**Re - Casey Fields South (Employment) and Devon Meadows
Precinct Structure Plan
165 – 215 Clyde Five-Ways Road, Clyde**

KLM Spatial acts on behalf of Galileo Clyde Fiveways Pty Ltd in providing the following response to the exhibited Draft Casey Fields South (Employment) and Devon Meadows Precinct Structure Plan ('the PSP'). Galileo Group is an independent Australian development group with many successful greenfield developments in Melbourne's south-east.

Figure 2: From Plan 9 Infrastructure & Development Staging, Draft CFSDVSP. Outfalls as numbered

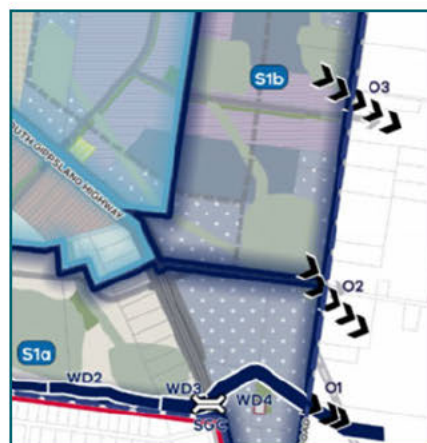
However, we consider the lack of a secure outfall at O2 to Rutherford Creek is a major inhibitor to the development of approximately 75% of the precinct north of Moore Road. The existing culvert at Moore Road disperses across neighbouring farmland. The absence of a secured outfall will prevent and frustrate the delivery of land and jobs across the core of the precinct.

Galileo presents an alternative drainage strategy intended to provide for efficiency of drainage outfall and assets with a guaranteed outfall to unlock land development by way of:

- Combining outfalls 01 and 02 with an outfall at 01 secured by the PAO by diverting drainage from the central northern catchment to the south of the proposed Moore Road extension,
- Providing an efficient wetland within a natural low lying basin area connecting to the PAO outfall and extending the PAO to include this wetland,
- Providing primary treatment upstream prior to stormwater entering the channel system,
- Locating the alternative wetland within a location that is largely impacted by a Land Subject to Inundation Overlay,
- Realigning of waterways north of the Moore Road extension to direct drainage to the alternative wetland, and
- Producing land efficiencies for 215 and 235 Clyde-Fiveways Road and 1805 South Gippsland Highway through the alternative wetland proposal.

Figure 3: Alternative Drainage Concept

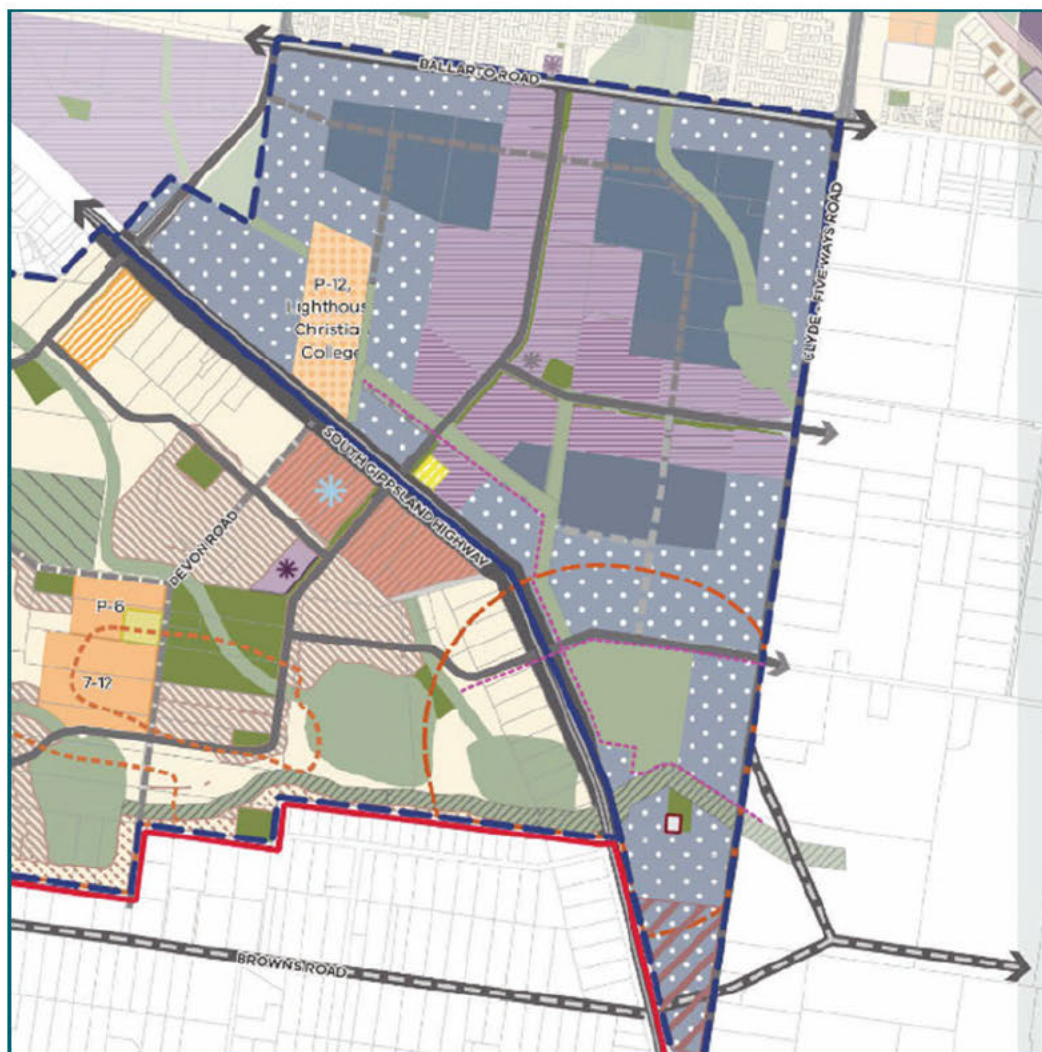
The alternative drainage scheme achieves an approximate **40% reduction of wetland area** and a minor reduction of waterway length, as well as requiring two rather than three outfalls. The wetland would provide stormwater retardation for approximately 85% of the Casey Fields South precinct, only excluding the small catchment to the north-east of the precinct.

The significance of the proposed wetland provides appropriate justification that a **PAO should be applied to the wetland area**. This will enable certainty of delivery and enable the wetland to be constructed concurrently with outfall 01. This would unlock developable land in the precinct and may avoid temporary drainage works.

1. All PSP Plans 1-13 be amended to incorporate the alternative wetland and waterway configuration
2. Plan 6 Water - delete wetlands RB_01, RB_02 and RB_05
3. Plan 6 Water – Identify the alternative efficient wetland as RB_01
4. Plan 9 Infrastructure and Development Staging - Delete Outlet 02 and renumber Outlet 03
5. Table 8 Water Infrastructure – to be amended to reference to appropriate descriptors for the alternative scheme (alternative table to be provided separately)
6. Amend R8 to delete referenced documents and instead state,

Figure 6: From Alternative Drainage Scheme

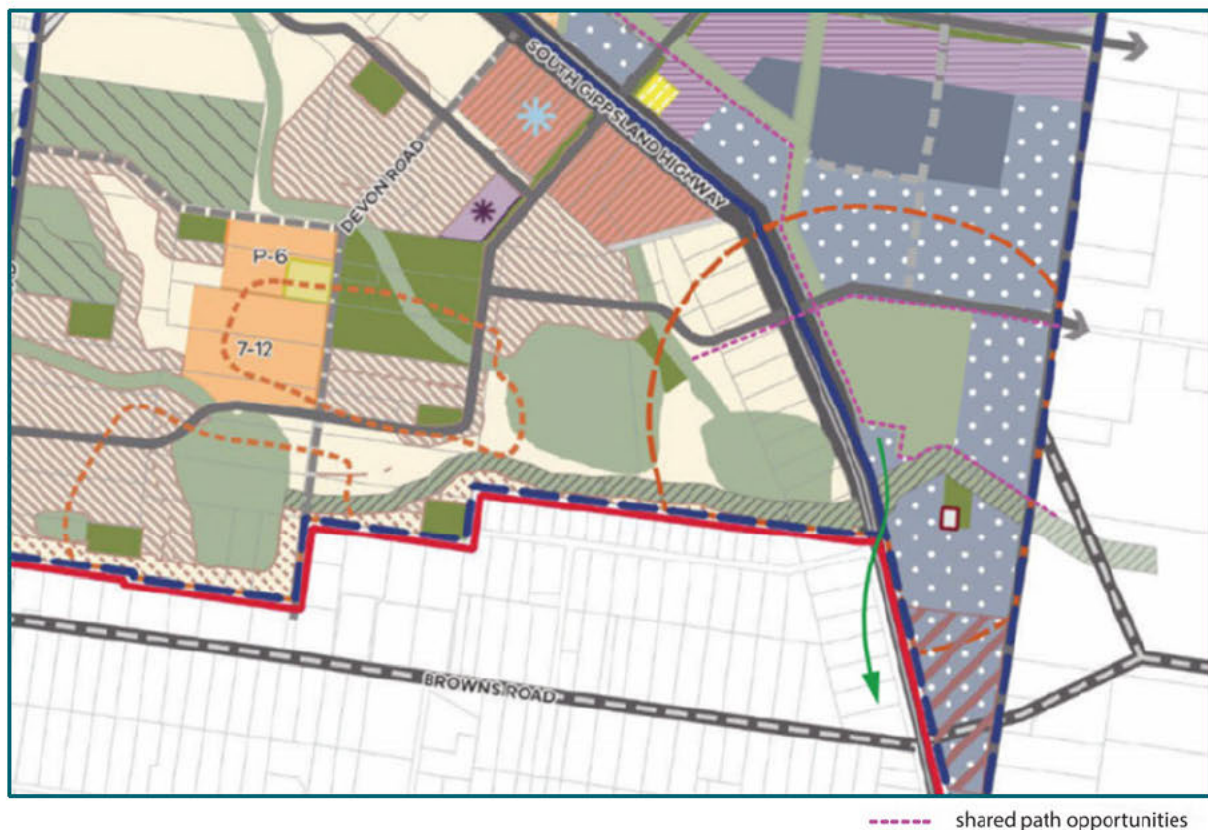
The proposed wetland location extends the 'chain of wetlands' proposed through Devon Meadows precinct eastward. This provides more opportunity for attractive open space with shared path linkages between the future Devon Meadows and Clyde South residential areas, as well as extending a 'low priority link' for South Brown Bandicoot and other native flora and fauna.

Figure 7: Alternative Staging Proposal

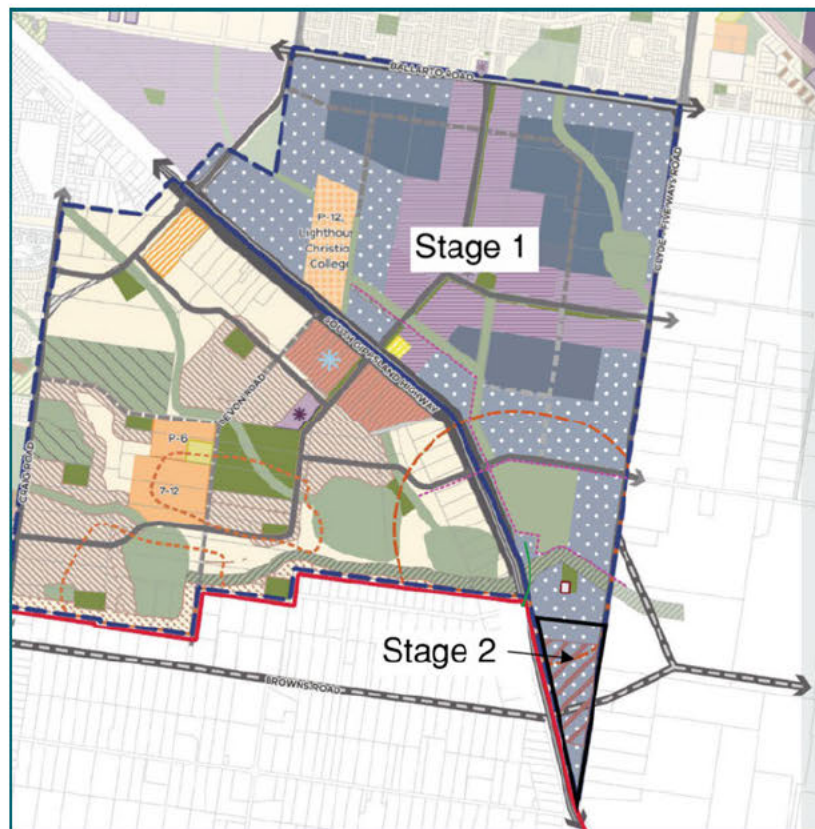
If the VPA is committed to staging the Casey Fields South precinct we suggest that the triangular Investigation Area to the far south of the precinct be nominated as Stage 2, given this area is yet to be given consideration and its development of this area will require:

Stage 1 as proposed in this submission contains two drainage catchments with proposed outlets O1 and O2. The necessity for a downstream outlet will effectively guide the development of the two catchments within the proposed Stage 1 precinct but does not otherwise need to be restrained by a stage boundary.

1. Amend Plan 9 Infrastructure and Development Staging to reflect the staging in Figure 7.
2. Amend Plan 6 Water to show a Temporary Sewer Rising Main along Clyde Fiveways Road and the Sewer Pump Station located adjacent to that road.
3. R27 be amended for Casey Fields South as follows,

Figure 8: From High Level Utility Servicing Assessment, CFSDVPSP, June 2023, SMEC

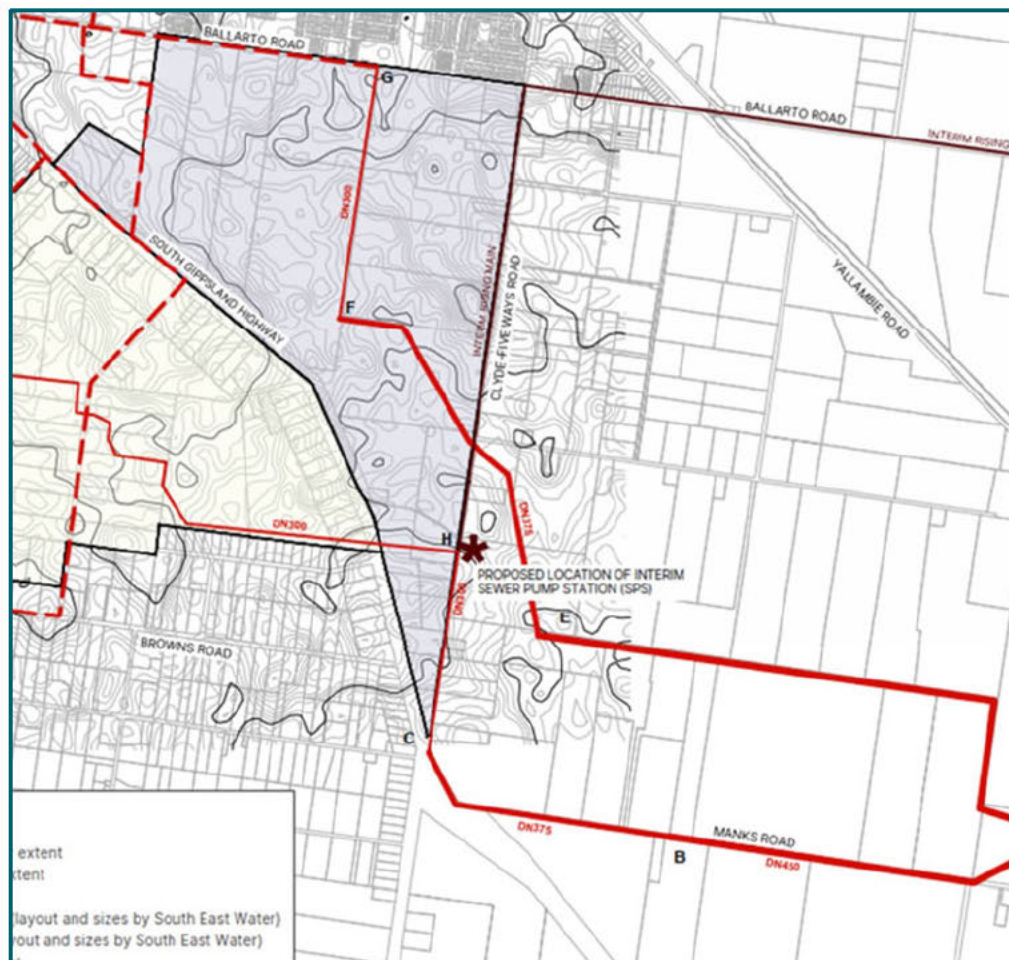
A temporary sewer rising main along Clyde Fiveways Road, as proposed in the background reporting, is a practical approach to delivering sewer infrastructure to the employment precinct given the Manks Road alignment in Clyde South may not be developed for many years due to fragmented ownership in that precinct. We strongly request the temporary rising main be shown in the PSP on Plan 6 Water.

Similarly, we suggest the temporary pump station is preferably located adjacent to Clyde Fiveways Road to facilitate access rather than central to the land parcel.

Figure 9: From Plan 4 Movement Network, Draft PSP

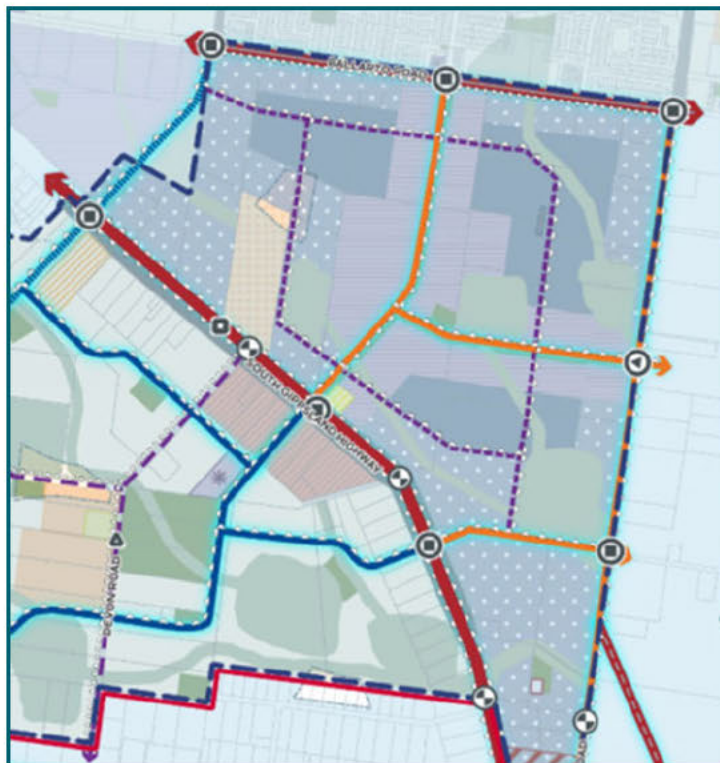
- The extension of Moore Road and signalised intersections at South Gippsland Highway and Clyde Fiveways Road, providing a key connection for the precinct and to the future Clyde South area,
- The Connector Street/Employment Avenue provided within and along the northern boundary of the Galileo land.
- A signalised T-intersection at the intersection of the above Connector Street and Clyde – Fiveways Road, particularly given the rolling topography of the road which could impact view lines if this intersection was to be unsignalized. Refer photograph below.

Figure 13: Movement network plan with additional east-west Connector Street indicated

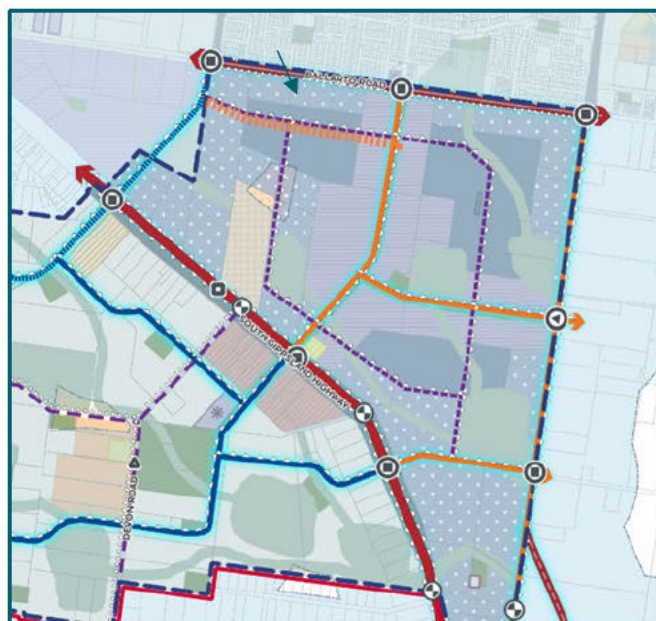
It may be desirable, however, for the northern east-west Local Access Street to be upgraded to a Connector Street to improve precinct access to the future Casey Fields Boulevard, as indicated in the image below

1. Amend Plan 4 Movement Network to:
 - Delete Local Access Streets on plan
 - Include a new east-west Connector Street to Casey Fields Boulevard as indicated in Figure 12.
2. Amend G16 by deleting the following dot point
 - *Minimise vehicle access from Employment Avenue streets on Plan 4 Movement network*
3. Delete Connector Street Employment Avenue cross section which does not provide for car parking.
4. Delete Limited Access Connector Street cross section which includes an unnecessary Loop Road adjacent to the Connector Street.
5. Delete Local Access Street – Employment Service Loop which does not include car parking lanes, and replace with standard 'Local Access Street – Level 2 (Industrial)' as per Officer South Employment PSP, increasing the cross-section width from 20m to 22m and noting that an off road bike path is not included. Refer following image
